**MINED LAND RECLAMATION BOARD
BOARD ORDER FILE No. M-1977-410, MV-2021-017**

**QUARTERLY REPORT
FIRST QUARTER 2022**

**GRAND ISLAND RESOURCES LLC
CROSS AND CARIBOU MINES
NEDERLAND, COLORADO**

Figure 1: General site map with the locations of the water management and treatment system, and specifications for piping through the system. Figure also displayed in Appendix B, but shown here for improved understanding.

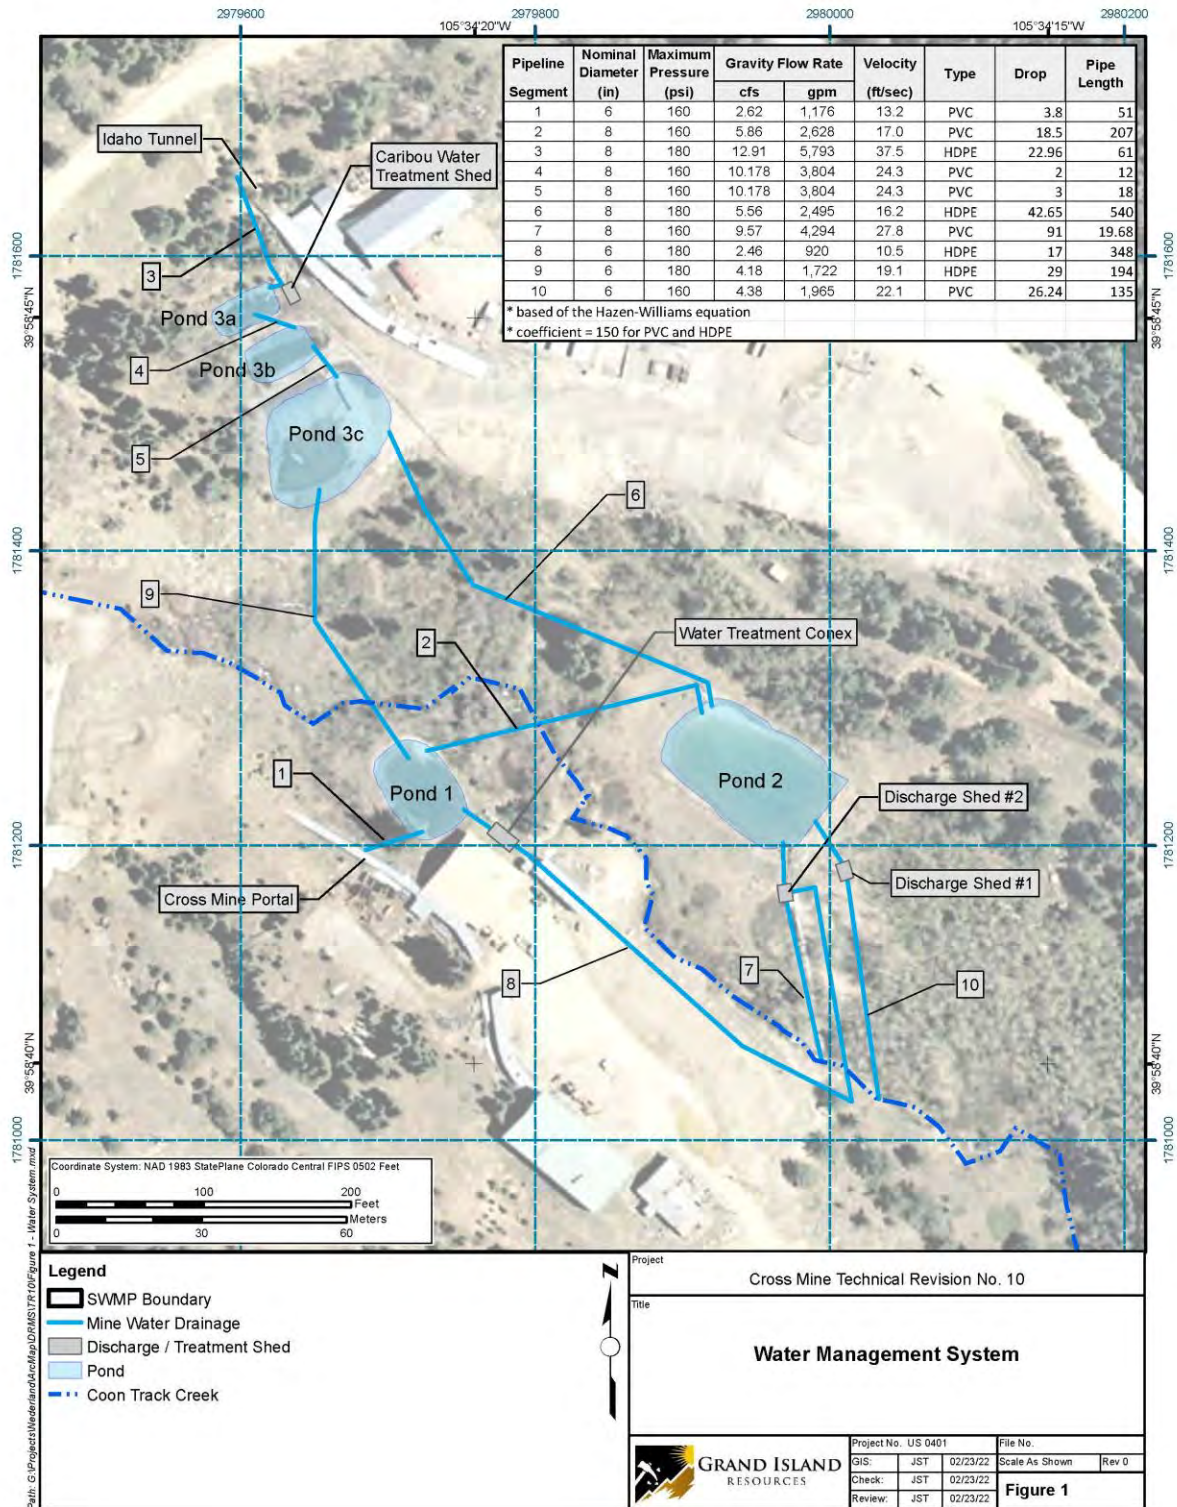
- 3) The Division has the following comments pertaining to Figure 1 – Water Management System:
 - a. Please add the approved permit boundary (at least the portions visible in the view shown).

- 13) The bond estimate calculated for Amendment No. 2 (AM-2; approved on February 8, 2022) includes costs for removing and disposing of a total of 777 feet of 6 inch diameter pipeline. According to Figure 1 – Water Management System, a total of 1,585.68 feet of pipeline is installed at the site, including a combination of 6 inch diameter and 8 inch diameter PVC and HDPE pipeline. Please provide a bond estimate that includes costs for removing and disposing of the additional 808.68 feet of pipeline.

Figure 14 Isolation Valve and Backwash Tank

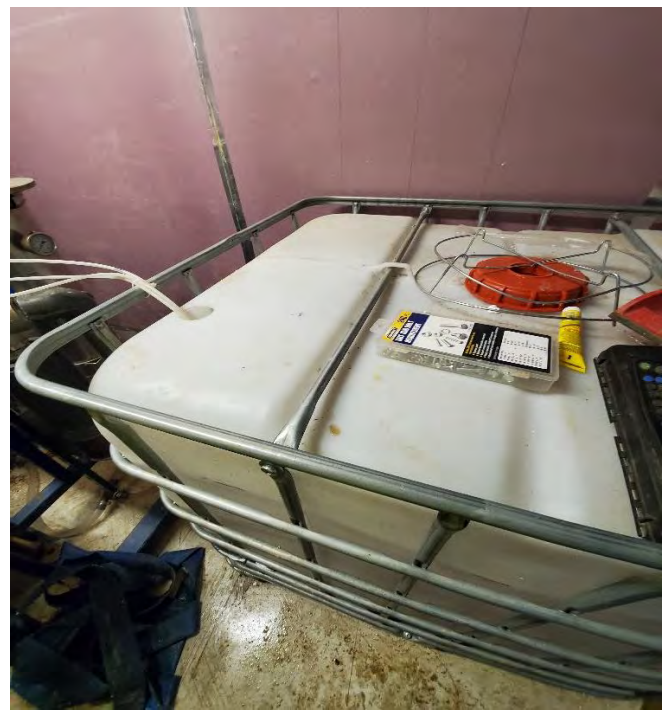
- 11) In Appendix A – Site Pictures, Figure 14 shows a photo of the “backwash tank” located inside the new water treatment shed. Please provide some additional information on the purpose of this tank, the nature of the water present inside the tank, whether the tank must be emptied regularly, and if so, where the water is poured.
